To: NSW Government Department of Planning & Environment
CC: RMS & NCC.

Objection to the EIS Exhibition – RMS Newcastle Inner City Bypass project

Figure 1 – My proposal for a shorter overpass for the West end connections to Jesmond Park

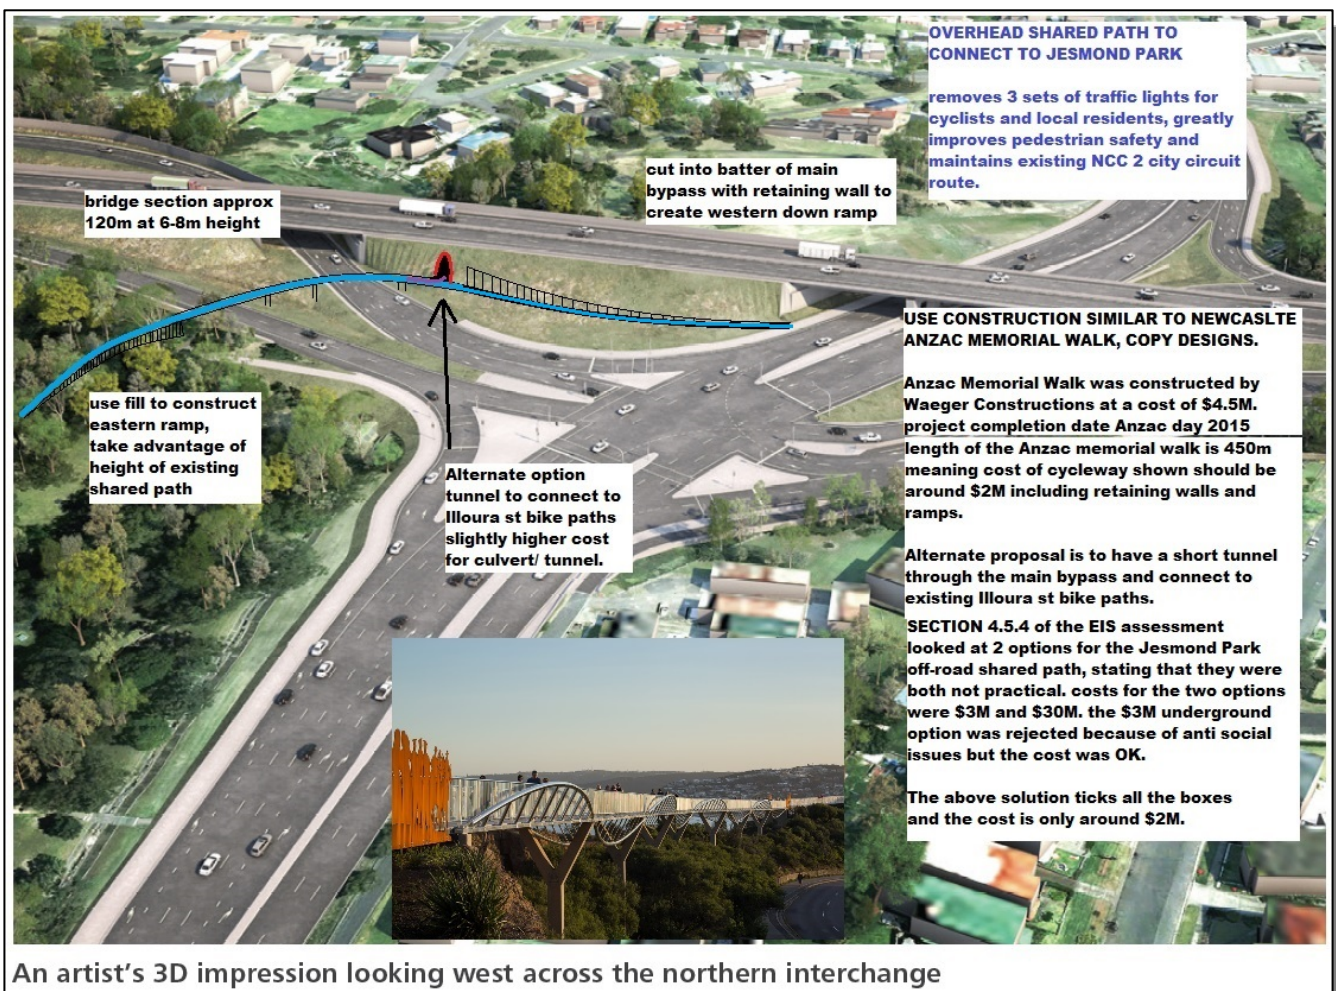
The key issue to recognise here is that the overpass option does not need to be 12m in height and does not need to cross the main bypass itself to maintain the shared path connection.

I propose that the RMS adopt a reduced overpass option approximately 120m in length across the two off ramps only. The reduced overpass which is much shorter in length and lower in height can be constructed at a lower cost without any of the anti-social or drainage issues. I have attached a sketch of my proposal below.

The important consideration in keeping the costs down is to make use of the height of the existing shared path and also available fill materials to construct the access ramps. The shared path at the eastern end of the overpass is above the road level, meaning that a shorter ramp with less material is required.

For the western end of the bridge the batter of the main bypass can be used to create the other down ramp – a much lower cost option than constructing a ramp from concrete and steel. Alternatively a very short culvert or tunnel could be included to connect to the existing path at Illoura Street / Victory Parade significantly shortening the overall length of the shared path.
